4000200 Concrete Structures.
COMMENTS FROM INTERNAL/INDUSTRY REVIEW

DETAIL "B"
UNDERDRAIN DETAIL
(Similar to Type II ~ Index 286)

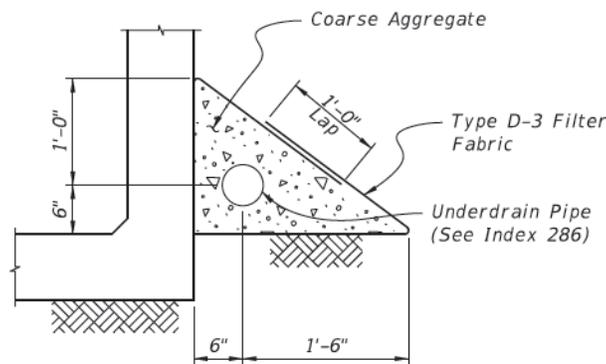
Comments: (10-12-11) Text: The problem statement on the Origination form states: Weep holes in box culverts are not always required by design; however the FDOT Specifications currently requires weep hole in all box culverts. This should probably be corrected since current specifications only require weep holes in culverts with a wall height in excess of 5'. The origination form does not indicate whether or not there is a corresponding change to the Plans Preparation Manual associated with this change. Since the proposed specification change will now require weep holes for culverts to be shown in the Plans, it is suggested to confirm that this requirement is also included in the PPM. It is suggested that paragraph 1 of 400-6 be modified to simply state: Provide weep holes in all abutments and retaining walls. Provide a continuous underdrain for box culverts in accordance with Design Standard Index No. 289. Provide weep holes for culverts when shown in the Plans. The plans (or a Standard Index) should provide all additional prescriptive elements (details) which are outlined in the current & proposed specifications, including but not limited to: • Symmetrically located weep holes. • Weep holes that are 3" in diameter & not more than 10' apart. • Weep holes that are not placed under areas of base or pavement. • Outlet ends of weep holes placed just above the ground line in front of abutments & retaining walls. • Weep holes on culverts that are placed approximately 6" above the interior floor slab. • Exterior openings of weep holes covered with galvanized mesh with a minimum of 2cf of clean, broken stone or gravel wrapped in Type D 3 filter fabric.

Comments: (11-9-11) District 4 Construction has the following comments. "Provide a continuous underdrain for box culverts in accordance with Design Standard Index No. 289." I don't see any mention of underdrains in STD 289.

The Problem Statement in the Origination Form is changed as follows:

Weep holes in box culverts are not always required by design; however the FDOT Specifications currently requires weep hole in all box culverts over 5 feet in height.

The comments regarding changes to the PPM and Design Standards were forwarded to the State Drainage Office for possible inclusion in the 2013 PPM and Design Standards. The new detail that will be shown on sheet 5 of Index 289 of the 2012 Design Standards is shown below.

12-2-11 From the State Specifications Office (HRP): Based on conversations with Andre, the specification will be changed to no longer require weep holes in box culverts. There is no apparent need to provide weep holes in box culverts and the current requirements cause confusion in the field resulting in questions. If for some reason, a designer feels weep holes are needed then the details would be shown in the plans. The requirements for weep holes in retaining walls and abutments remain unchanged. A continuous underdrain will be required for box culverts to aid in drainage as shown above.

Response: The 2012 Design Standard Index No. 289 will have a new detail (shown above) for the continuous underdrain.
